# US-OR-32-8 METRO: MULTNOMAH CHANNEL & SMITH BYBEE WATER CONTROL STRUCTURES FACILITY IMPROVEMENTS

## 90% DESIGN

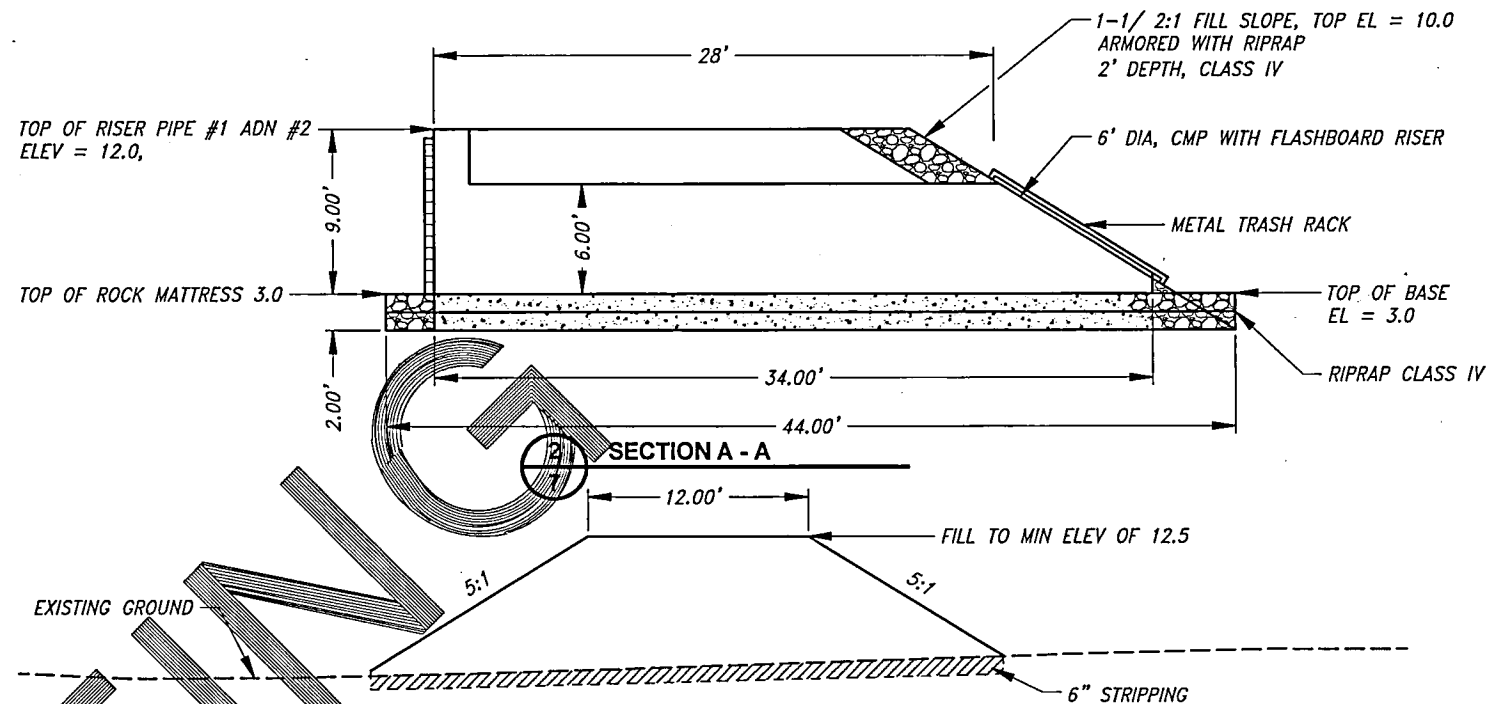
4. The contractor shall comply with all local and state requirements relative to the notificatcion of the applicable unerground service alert.
5. At least 2 working days prior to beginning any digging or excavation work, the contractor shall notify underground service alert of Southern California (a.k.a. DigAlert) at www.digalert.org or by phone at 811, to determine locations of existing utilities. → ?

PROJECT NO. <b>US-OR-32-8</b>	DATE: <b>6/22/2016</b>	DESIGNED BY: <b>GW</b>
<b>METRO: MULTNOMAH CHANNEL NORTH SITES</b>		DRAWN BY: <b>DMC</b>
		SURVEYED BY:
		CHECKED BY:
<b>ALUMINUM STOPLOGS</b>		SHEET NO. <b>12 of 18</b>

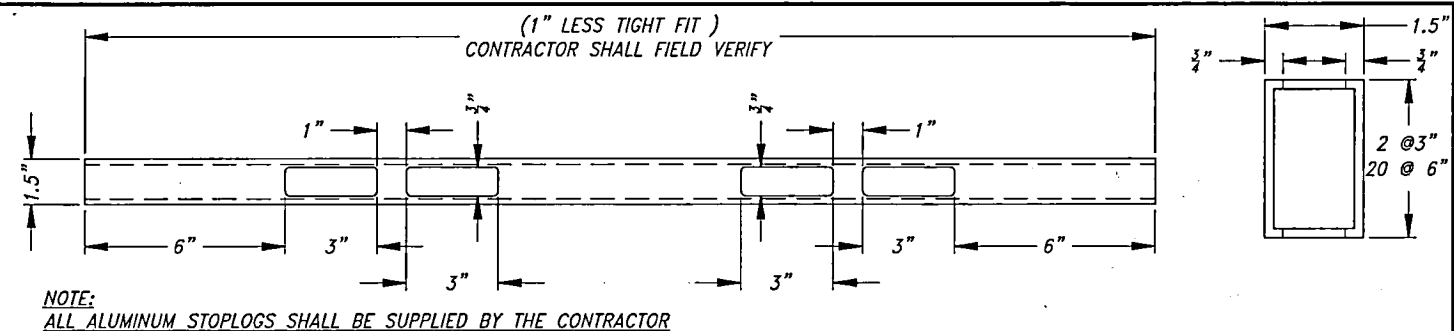
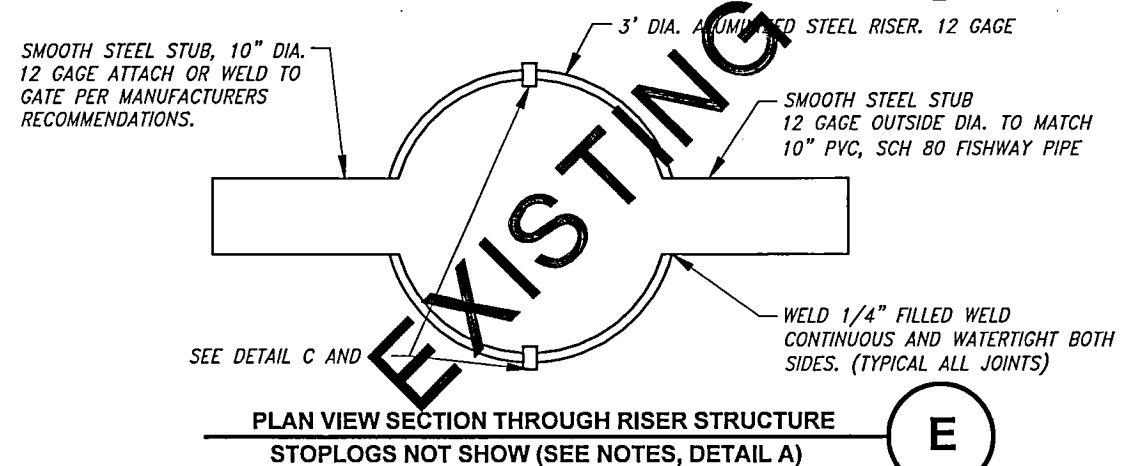
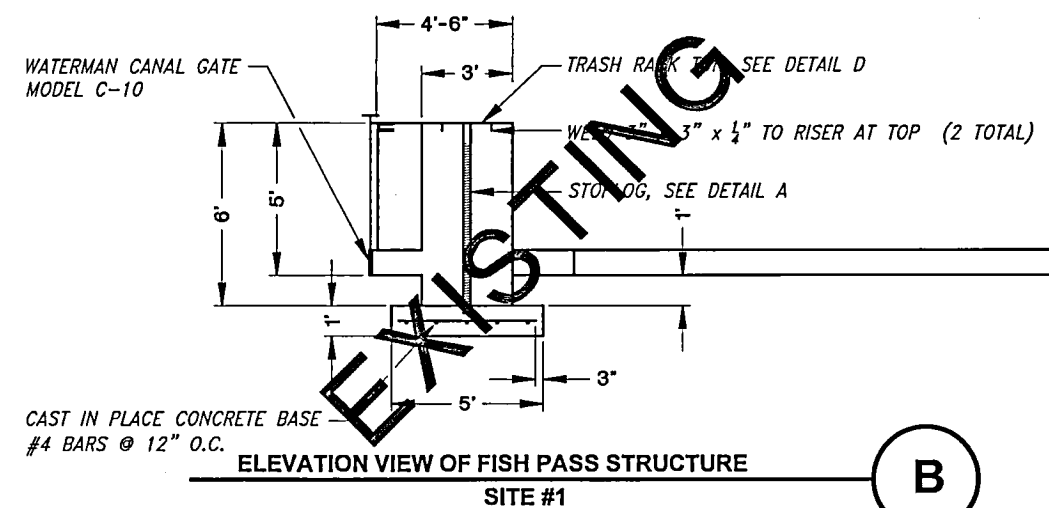
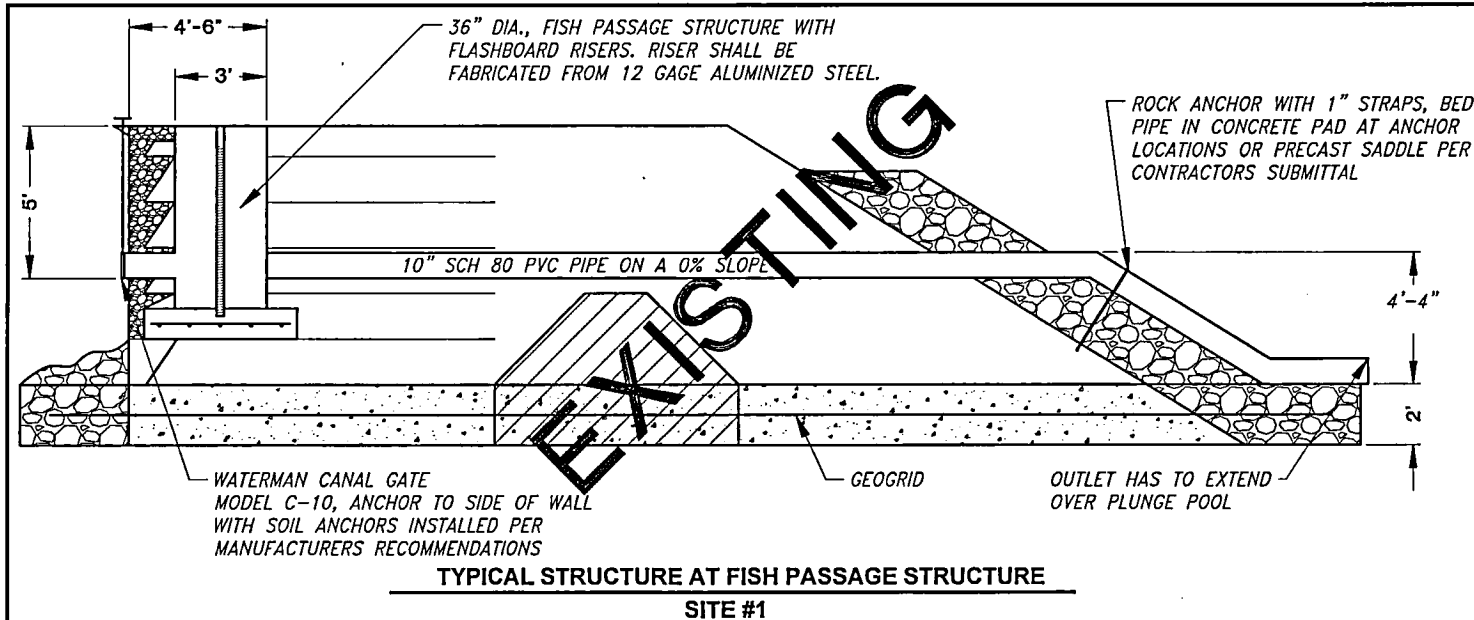
Does this refer to center bay of structure?  
or center of fishway bay?  
Stop logs only in fishway  
90% DESIGN

**3 TRASH RACK**  
**15**

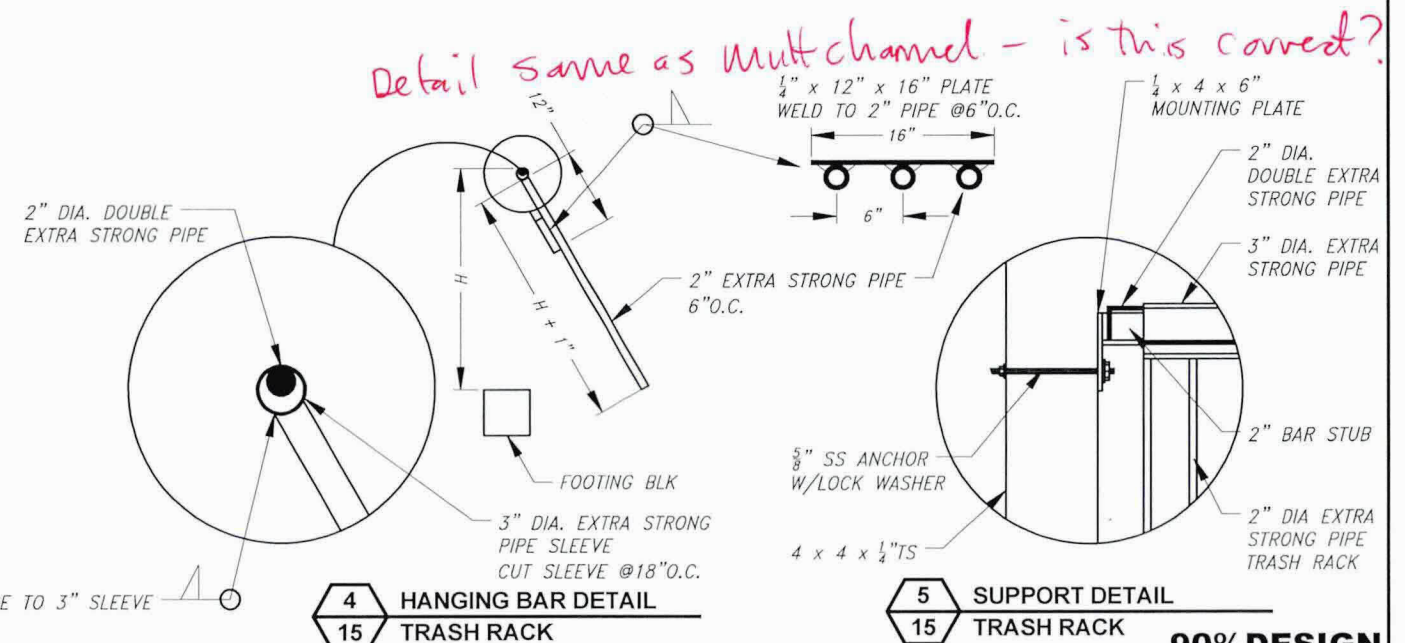
Not sure if this is needed. We weren't going to leave this gate as is. See phase 2 scope.
